**RISO INC.** **TECHNICAL INFORMATION BULLETIN**

Subject: Pick Up Roller/Assembly | Bulletin No: 39

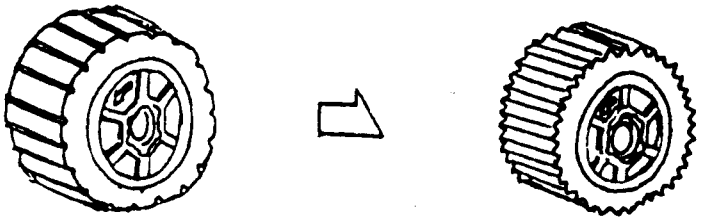
Purpose: The shape of the teeth of the rubber roller and the quality of the rubber has been improved to aid in feeding low quality papers.

The surface of the old-type Pickup Roller

The surface of the modified Pickup Roller

Part # Ass'y/pick up roller II #007-11330-003
Rubber Roller II/Pick up # 007-11331-000
